**APPLICATION NO:** 14/05709/F                      Full Planning  
**EXPIRY DATE:** 13 January 2015

**Construction of 5 no. detached houses with integral garages and private gardens.**

**Development Control Committee B – 24 June 2015**

**Application No. 14/05709/F: Land Located Between Nos. 5 & 11 Bramble Drive Sneyd Park  
Bristol BS9 1RE**

A 20-02-15 Revisions following BCC comments JB JB  
 Rev. Date Amendment Drawn Checked  
 Client / Project  
**BRAMBLE DRIVE, SNEYD PARK, BRISTOL**  
 Drawing Title  
**LANDSCAPE PROPOSALS**  
 Scale Date Drawn Checked  
 1:200 @A1 SIZE 22-04-14 JB JB  
 Drawing No.  
**628-02A**

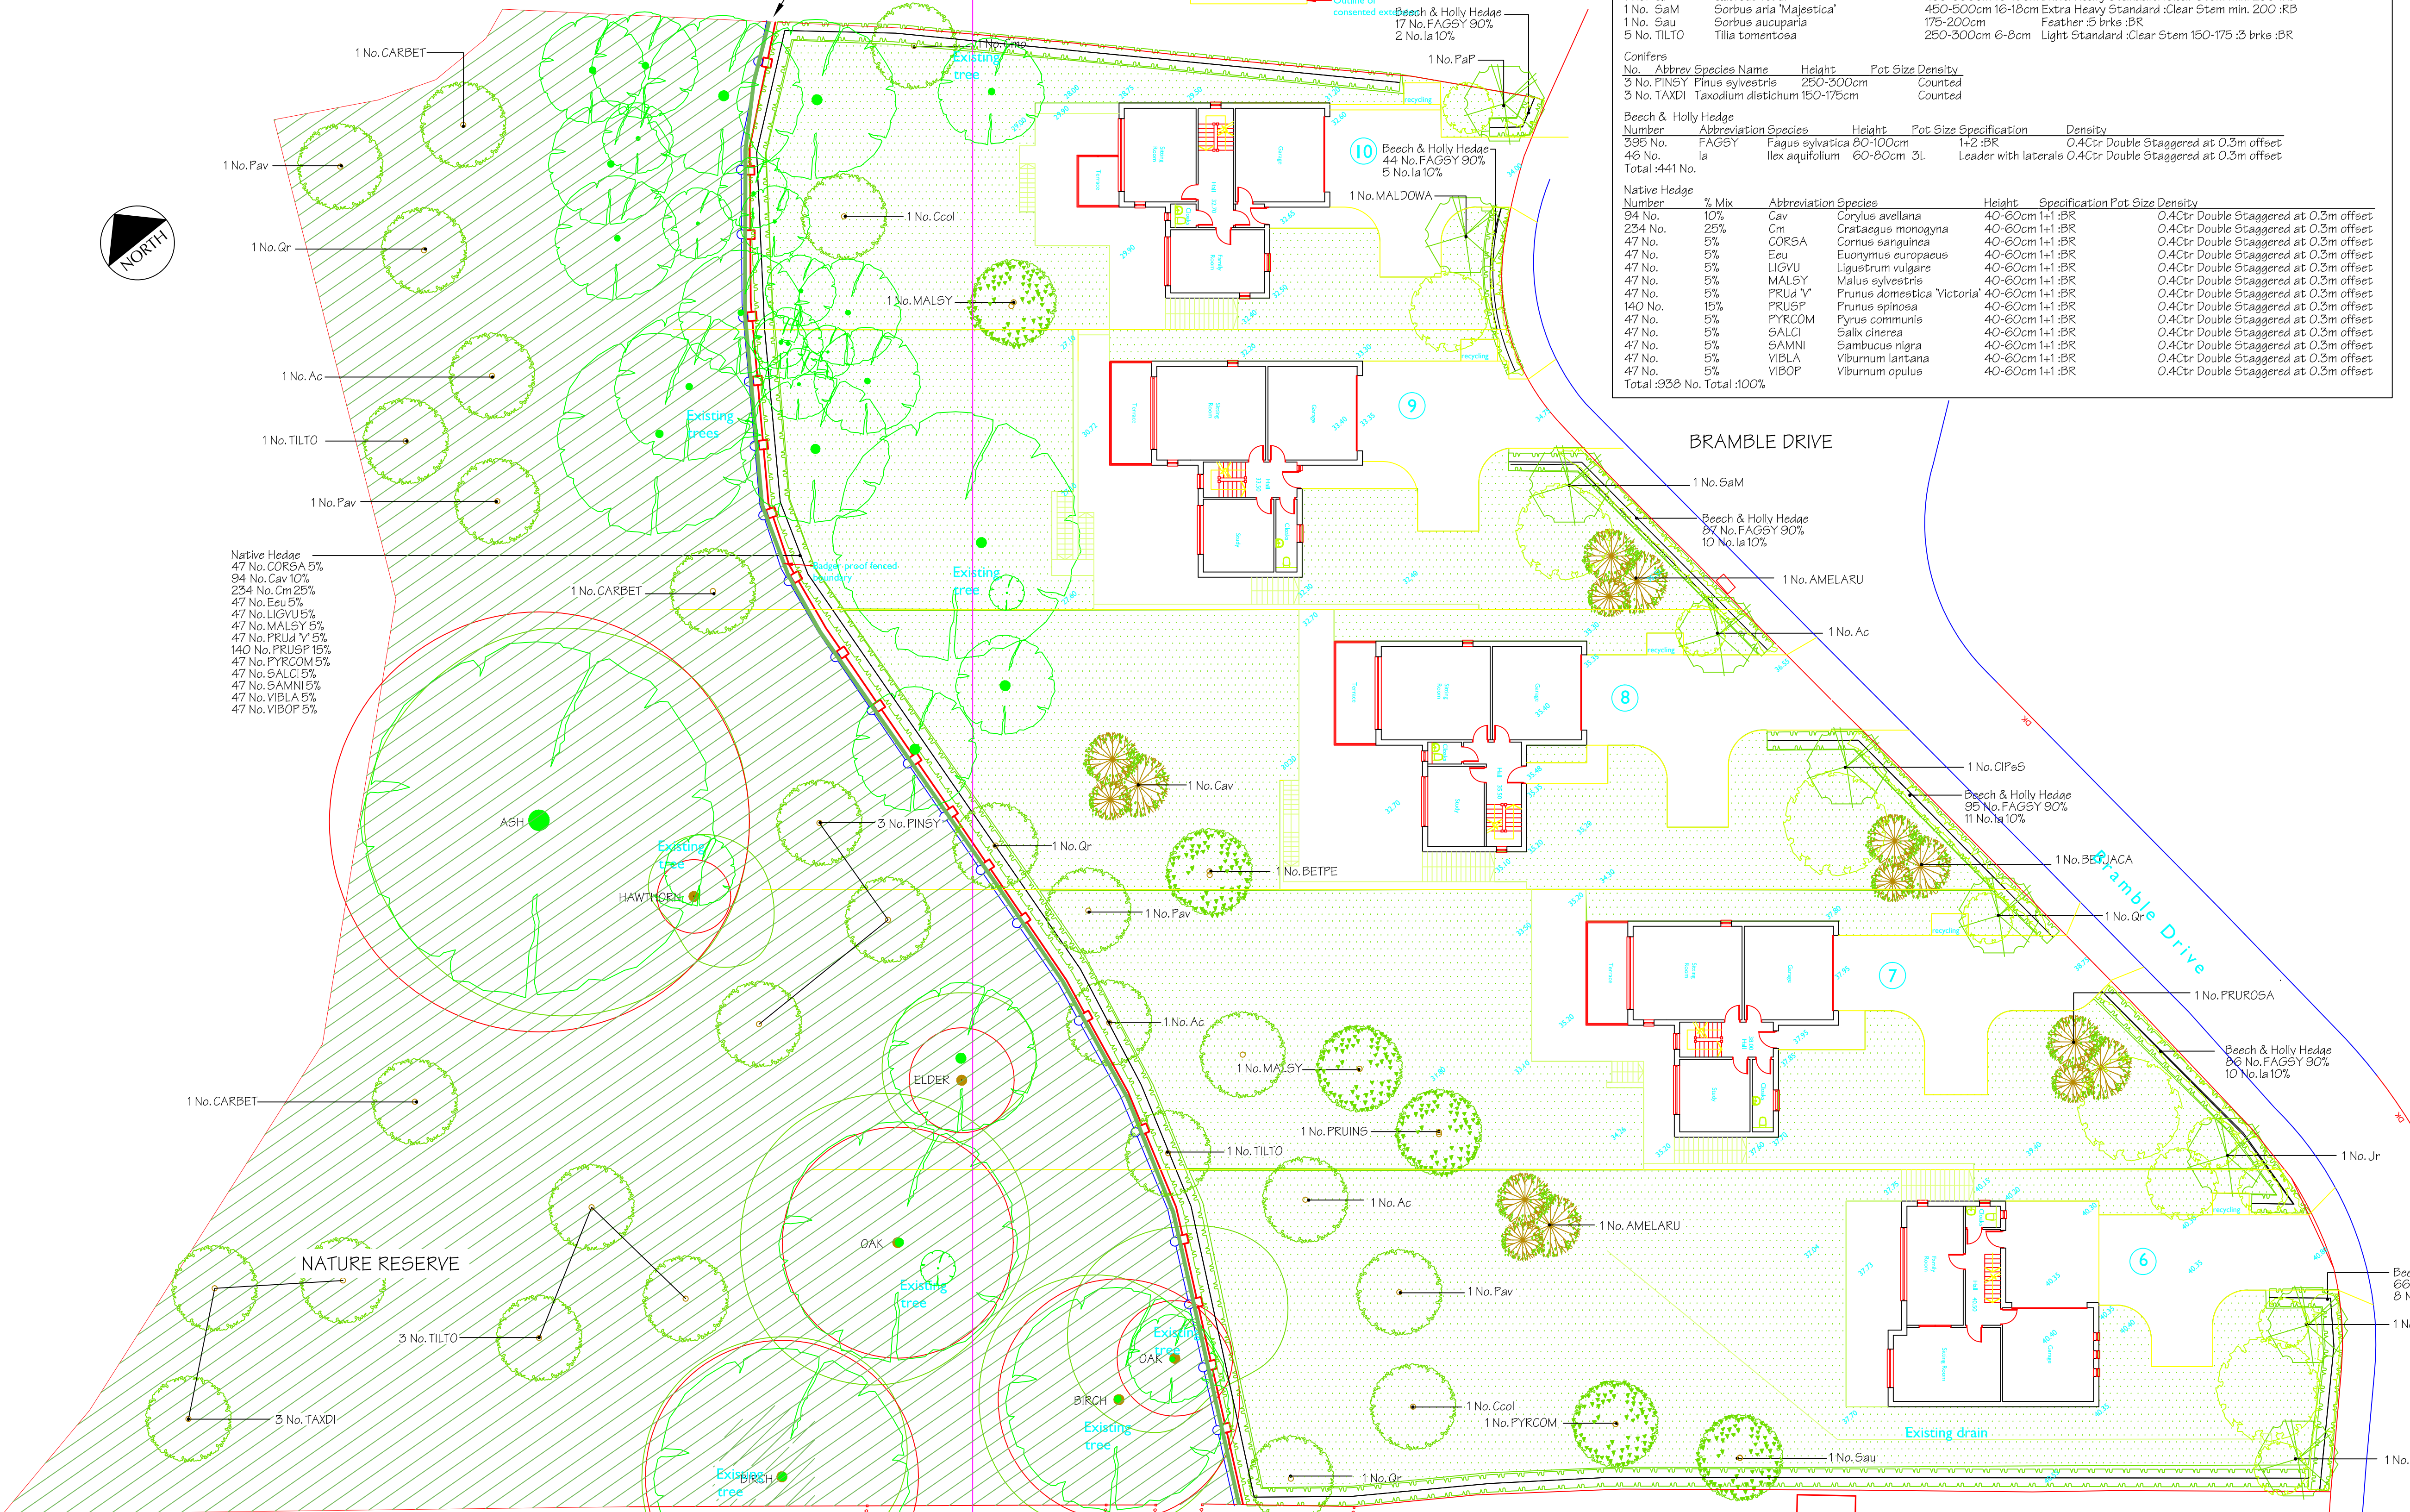
The proposed wildlife corridor on the north-western boundary of the site would be secured by robust metal palisade fencing as shown on the Landscape Proposals Drawing Number 628-02 and this is welcomed. The fencing should be paid for and maintained by the developer to the west of the rear of the gardens which adjoin the proposed wildlife buffer area. If trees are proposed to be planted within the wildlife corridor these should be predominantly native fruit trees to benefit foraging badgers and birds.

Current proposals to plant 23 small species such as amalanchier and sorbus in the rear gardens of the properties (albeit with a lengthy hedgerow) does not adequately satisfy the Bristol Tree Replacement Standard.

The landscape plan No 628 02A looks much improved with more robust planting between the development and the Nature Reserve, an important component to contribute towards the mitigation of trees lost to accommodate the development.

The fencing to the wildlife corridor shall be completed in accordance with the position and specification set out on drawing 628-02A, and shall be completed prior to the first occupation of the development hereby approved. Thereafter the fencing shall be retained and maintained as such.

The planting proposals hereby approved, as set out on approved drawing 628-02A, shall be carried out no later than during the first planting season following the date when the development hereby permitted is ready for occupation or in accordance with a programme agreed in writing with the council. All planted materials shall be maintained for five years and any trees or plants removed, dying, being severely damaged or becoming seriously diseased within 5 years of planting shall be replaced with others of similar size and species to those originally required to be planted.
